Detailed Response to Submissions Table

Bon Marche and Science Precinct Redevelopment
UTS City Campus, Broadway Precinct

Submitted to Department of Planning and
Environment

18 April 2019 | 218424

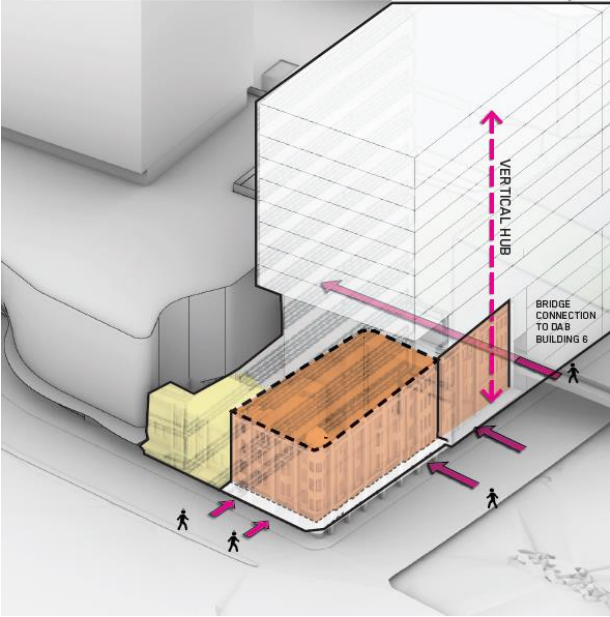
Recommendation/Issue	Response
<p>The scope (extent and location of the Competitive Design Process(es)) should be clarified and extended to include all buildings that are the subject of the proposed modification application to enable an integrated architectural design solution for the whole of site.</p>	<p>The Competition/s will only apply to that part of the Bon Marche and Science Precinct subject to significant redevelopment (i.e. as part of the demolition of Building 4/Building 3).</p>
<p>Competition jury composition</p>	
<p>The Jury composition should be clarified to adhere to the draft GA's Design Excellence Strategy Guidelines which require the following Jury composition for an Architectural Design Competition:</p> <ul style="list-style-type: none"> • 2 Proponent nominees; • 2 (Local Authority) City of Sydney nominees, including at least one a member of the State Design Review Panel; • 1 GANSW representative or their nominee. 	<p>Jury composition remains consistent with City of Sydney's policy.</p>

<p>In addition to the above, it is recommended the following is included where a nominee has to withdraw prior to the completion of the Competition:</p> <ul style="list-style-type: none"> • If any of the above nominees has to withdraw prior to the completion of the competition, another nominee of equivalent credentials will be appointed by whoever originally nominated that juror. 	<p>Suggested wording added to updated Design Excellence Strategy (refer to Appendix J of the Response to Submissions Report).</p>
<p>Competitive process brief</p>	
<p>Page 8, Section 3.5 of the Design Excellence Strategy refers to the Competitive Process Brief.</p> <p>The Consent Authority for the subject modification application is the Minister. In accordance with the Policy, the Consent Authority endorses the Competitive Process Brief prior to the commencement of the Competitive Design Process.</p> <p>The Local Authority for the site (City of Sydney), must be invited to comment on the Brief and may exercise its discretion in accepting any invitation.</p> <p>It is recommended that this section of the Design Excellence Strategy is amended as shown in strike through and <i>bold-italics</i> below:</p> <p><i>The competition brief (the brief) will be prepared by the proponent who will liaise with the Consent Authority for endorsement the City of Sydney prior to commencement of the competitive process, as per clause 2.3 of the Policy.</i></p>	<p>Suggested wording added to updated Design Excellence Strategy (refer to Appendix J of the Response to Submissions Report).</p>

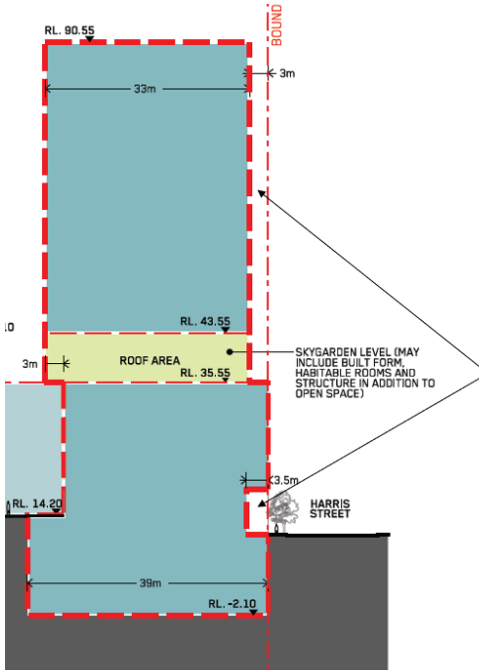
Development Contributions	
<p>The City of Sydney Development Contributions Plan 2015 ('the 2015 plan') applies to the site, and the site is located within the western precinct. The 2015 plan requires development which results in a net population increase (and which is not listed as an exclusion) to pay a</p>	<p>Development contributions are not a relevant matter for consideration for a concept plan modification application that does not provide for any physical works, as noted in the City's submission. A future detailed application will further consider the applicability and appropriateness of development contributions.</p>

Recommendation/Issue	Response
<p>development contribution towards the provision, extension or augmentation of local infrastructure.</p> <p>The Environmental Assessment Report (EAR) prepared by Ethos Urban on behalf of UTS discusses development contributions at Part 6.8. It argues that the redevelopment of the Bon Marche and Science Precinct should be exempt from development contributions, and notes that a detailed justification for an exemption will accompany a future development application for works.</p> <p>As the proposal is for a concept and not for physical works, development contributions are not directly applicable. They will become applicable at the detailed design stage. However, the request for an exemption from development contributions is not supported.</p>	
Height and Floor Space	
<p>The proposed height of Building 4 above Bon Marche is approximately RL 86.55. The height of the building is almost 2 times higher than the maximum 45m height limit standard in the Sydney LEP 2012.</p> <p>The proposed modification results in an increase in gross floor area of approximately 65,000sqm resulting in a total precinct floor space ratio (FSR) of 7.31:1 which exceeds the permissible FSR of 5:1. The FSR also exceeds the FSR of 5.5:1 permissible under the bonus provisions where buildings demonstrate design excellence.</p> <p>Whilst the City does not oppose an increase in height and GFA for the site, it is considered that the additional height and bulk of the development must respond appropriately to the built form of the adjoining heritage items and will not have any adverse environmental impacts on surrounding properties or the public domain in regard to overshadowing, wind, reflectivity, traffic, noise, flooding or stormwater.</p>	<p>It is noted that the City of Sydney have considered that the proposed modification results in an increase in gross floor area of approximately 65,000sqm. This is not correct. The proposal as exhibited sought approval for an additional maximum 36,500sqm of gross floor area. When considering the existing floorspace in the Science Precinct (i.e. Buildings 3, 4, 9 and 18), the additional floorspace proposed under this application will result in a total gross floor area of approximately 67,000sqm for the Precinct.</p> <p>The terms of the approval of the Concept Plan prevail despite anything to the contrary in an environmental planning instrument or development control plan. This includes the height and floor space requirements of the Sydney LEP 2012.</p> <p>The planning pathway under section 75W of the EP&A Act is a valid pathway for amending the planning controls as they relate to the site under the concept plan.</p> <p>The section 75W application supporting the change in controls has appropriately justified the proposal in terms of addressing any adverse environmental impacts on the surrounding properties or the public domain. This has included responding to submissions raised during the exhibition period, which has resulted in further modifications to the proposal – most significantly addressing heritage related concerns through removal of the cantilever to the Apothecary building together with provision of a setback above podium level along Harris Street.</p>
